November 11, 2015
BOARD OF COUNTY COMMISSIONERS
ORANGE COUNTY, FLORIDA
Y16-713-CC / ADDENDUM #1
JOHN BRIDGES COMMUNITY CENTER BUILDINGS D & F HVAC REPLACEMENT

Orange County John Bridges Community Center Buildings D & F HVAC Replacement

SHEET INFORMATION:	
JOB No. 100045178	Date Issued: OCTOBER 25, 2015
Designed By: LF	Sheet Number:
Checked By: FL	
QC Review: GFH	
Phase:	E-002

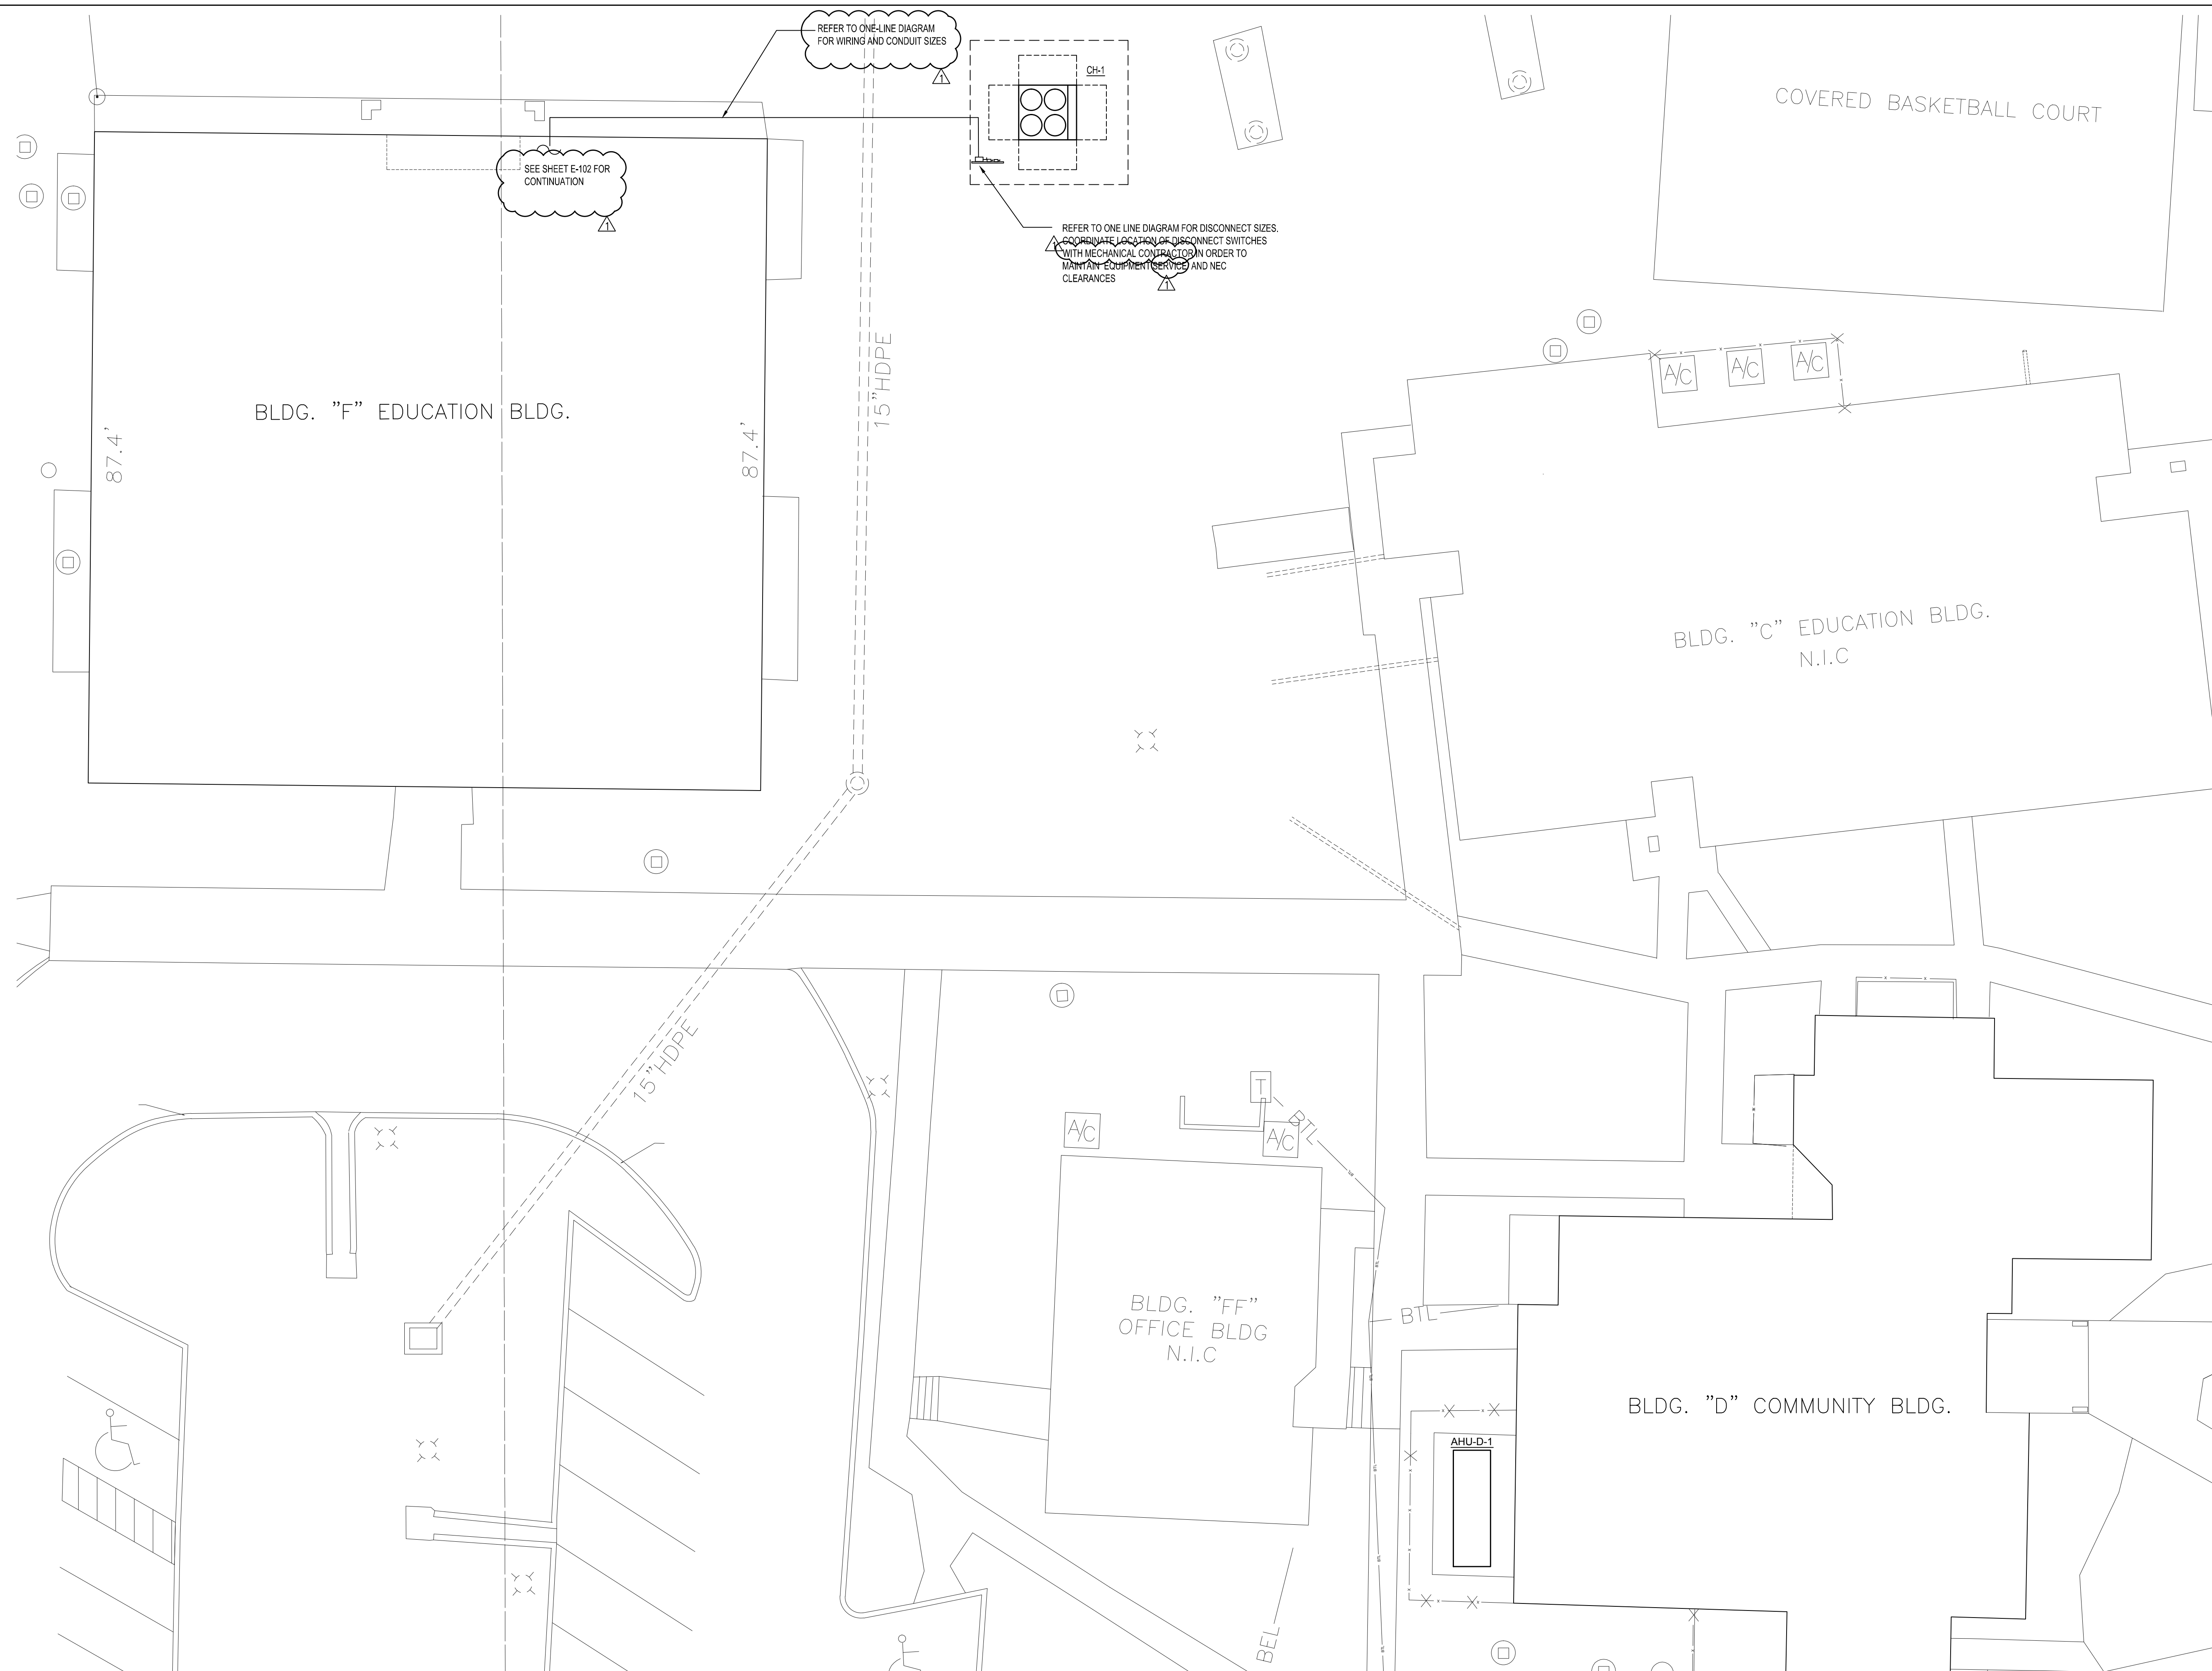
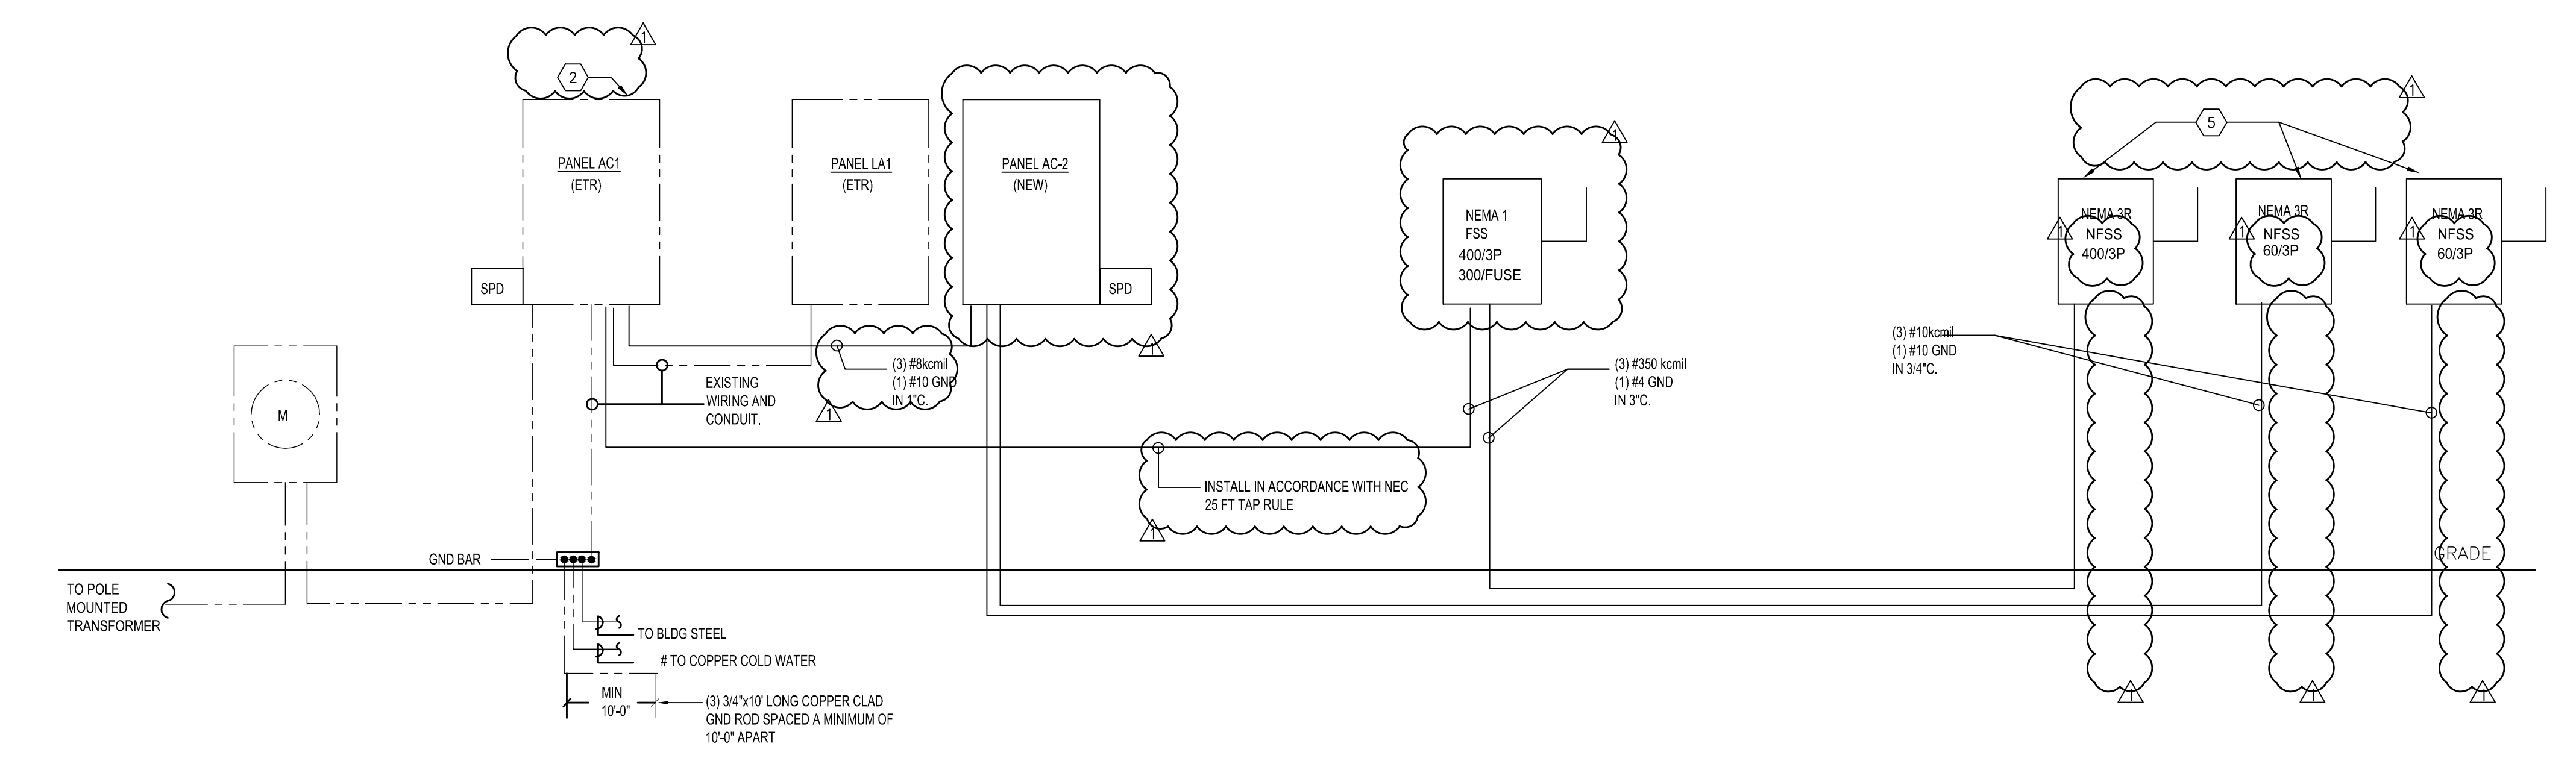
- E-000 -Text font was made consistent,
-added Scope of Work as General Note 1,
-added abbreviation for EXISTING TO REMAIN.
- E-002 -Text font was made consistent,
-added Panel AC-2 to 1-Line Diagram,
-added notes clarifying design intent for new chiller FSS (I.E 25 ft. tap rule),
-deleted ground rods at chiller yard, deleted TVSS units at chiller and chiller pumps disconnect switches,
-clarified Sheet Notes and Keyed Notes.

- REVISIONS**
- PROVIDE POST AND RACKING SYSTEM FOR CH-1, CHWP-1 AND CHWP-2 DISCONNECTS.
 - THE DESIGN INTENT IS TO PROVIDE FEED THROUGH LUSS ON EXISTING PANEL AC1 BUS AND FEED THE NEW CHILLER DISCONNECT SWITCH USING THE NEC 25 FT TAP RULE. IF IT IS NOT POSSIBLE TO INSTALL NEW LUSS IN EXISTING PANEL AC1 IN ACCORDANCE WITH U.L. RULES AND REGULATIONS, REPLACE PANEL AC1 WITH A NEW LINE TYPE SERVICE-ENTRANCE PANELBOARD. TO INCLUDE A 300 AMP CIRCUIT BREAKER FOR THE CHILLER. UNDER THIS OPTION, EXISTING SPD UNIT MAYBE RE-USED, AND THE NEW 400 AMP CHILLER FSS MAY BE RE-USED.

SHEET INFORMATION:	
JOB No. 100045178	Date Issued: OCTOBER 25, 2015
Designed By: LF	Sheet Number:
Checked By: FL	ED-101
QC Review: GFH	
Phase:

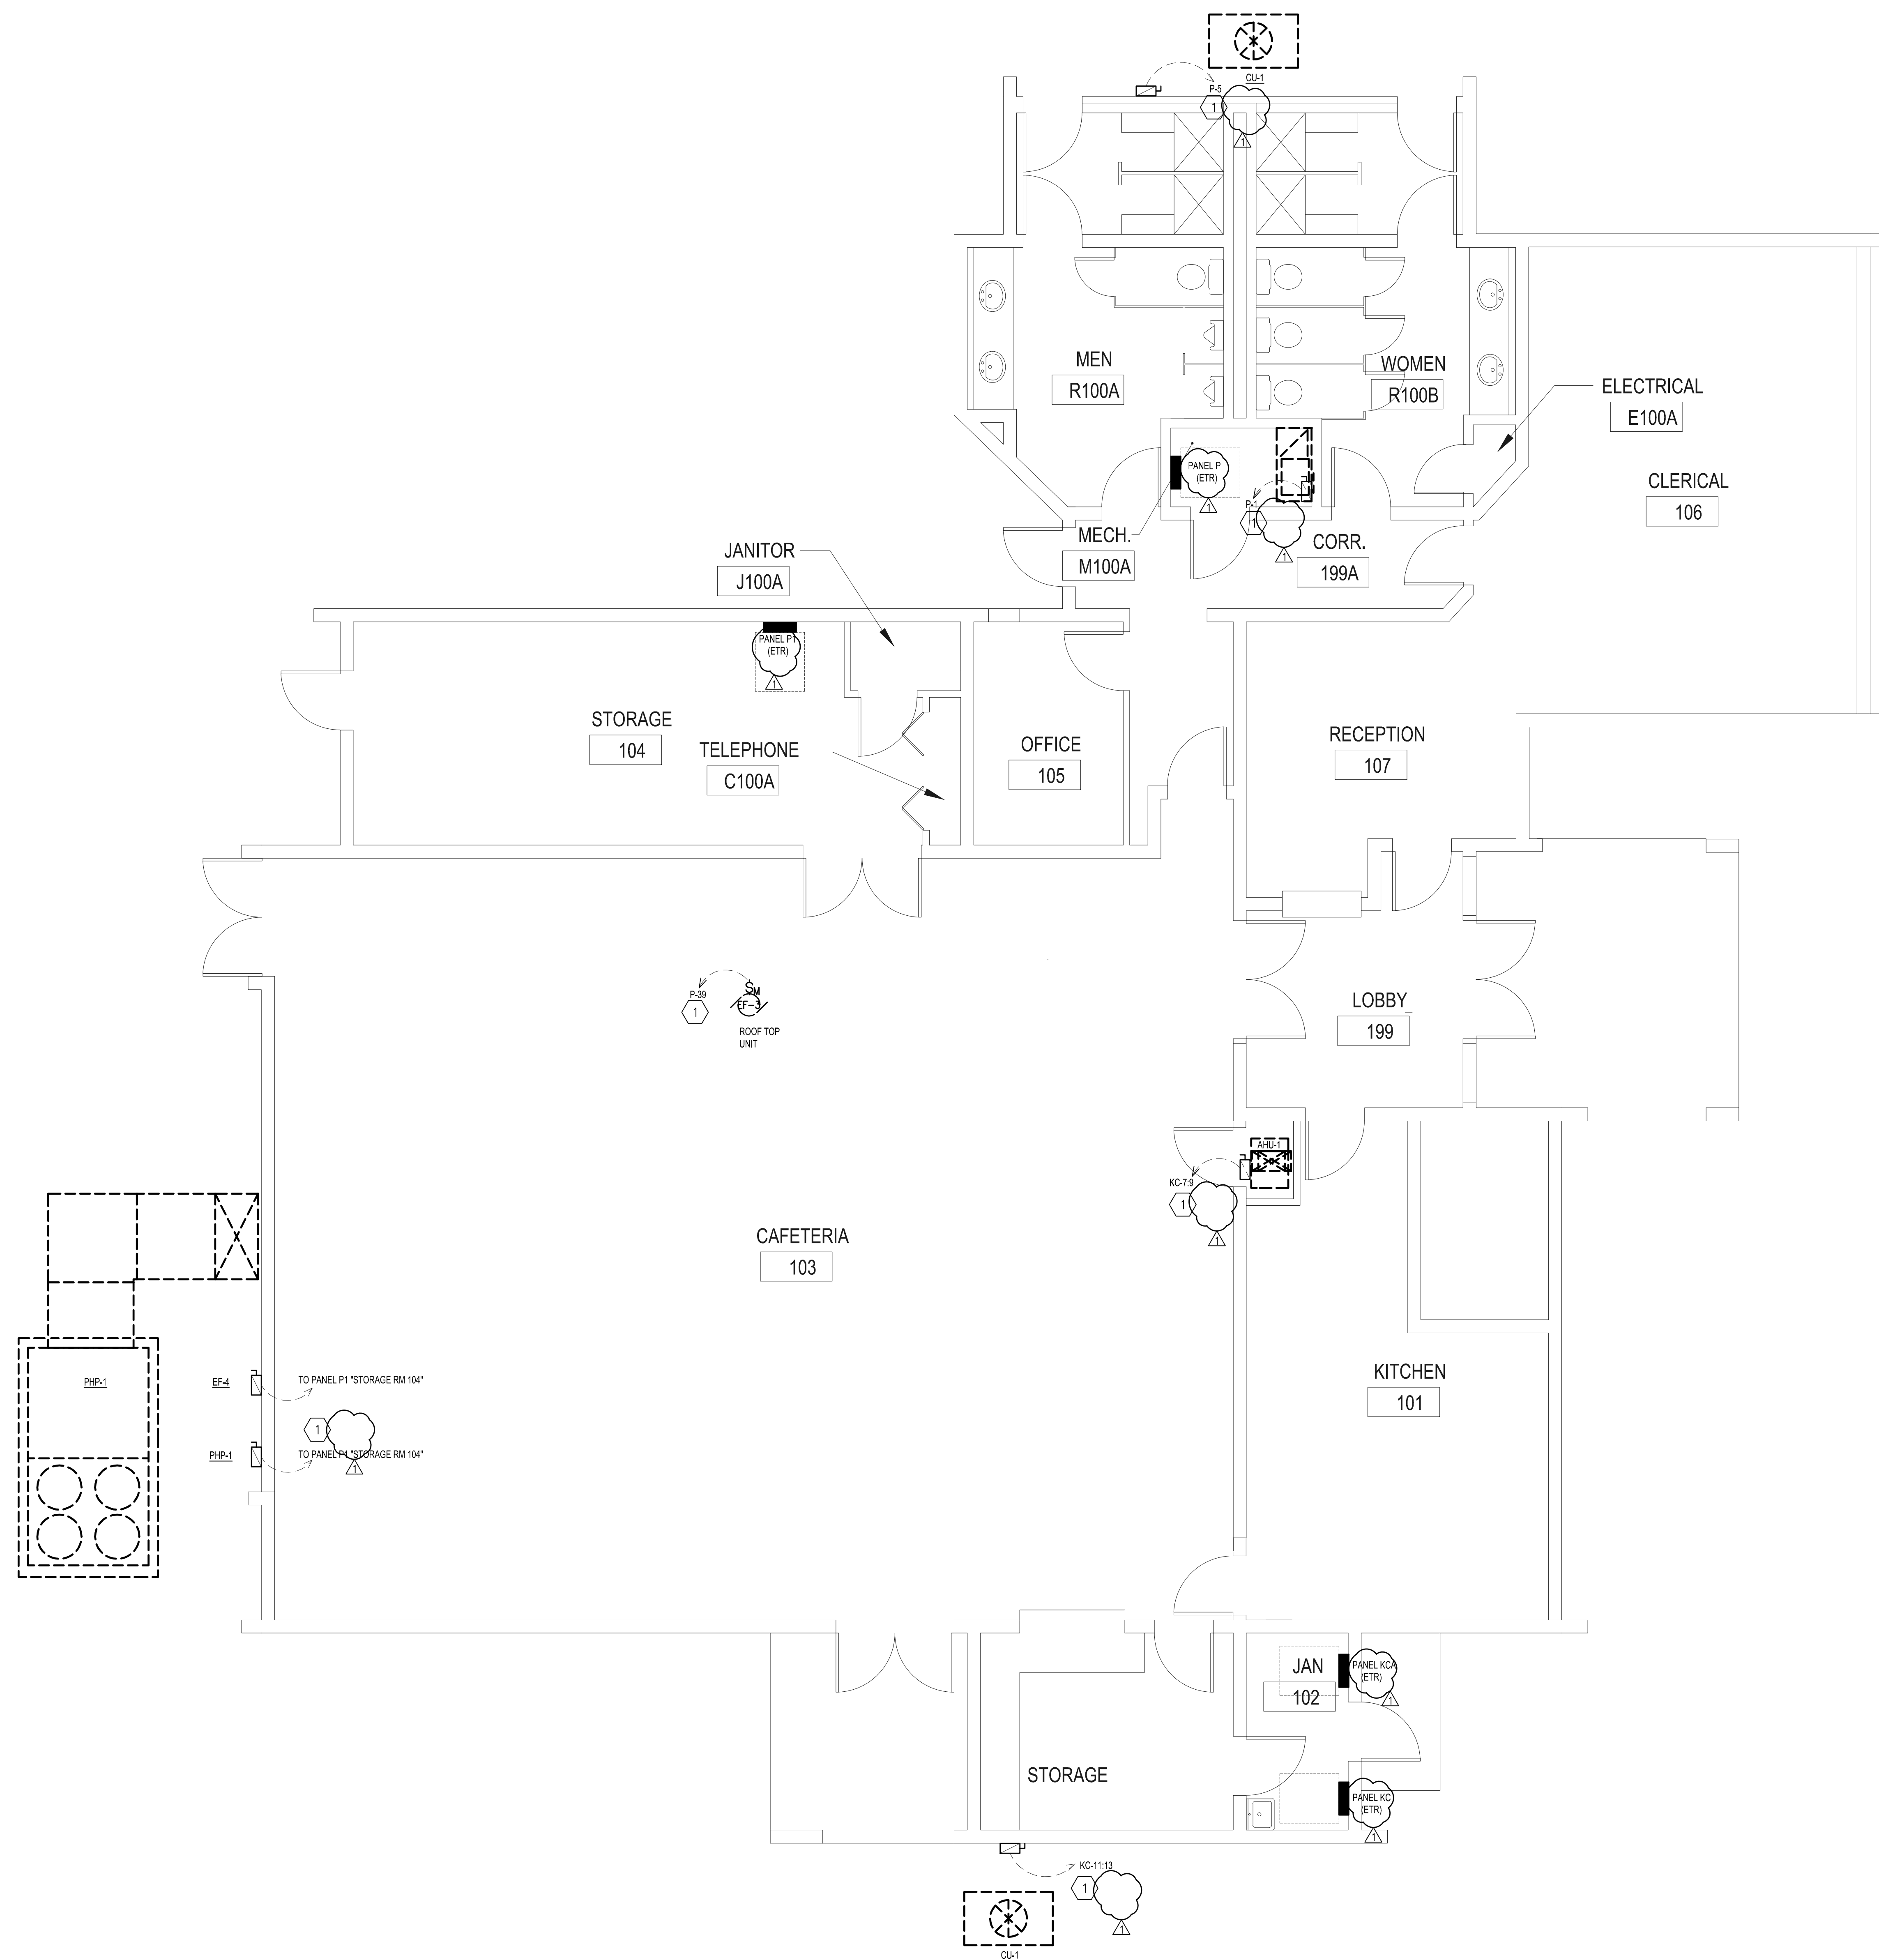
- ED-101 -Text font was made consistent,
-clarified Sheet Notes and Keyed Notes.
- ED-102 -Text font was made consistent,
-clarified Sheet Notes and Keyed Notes.
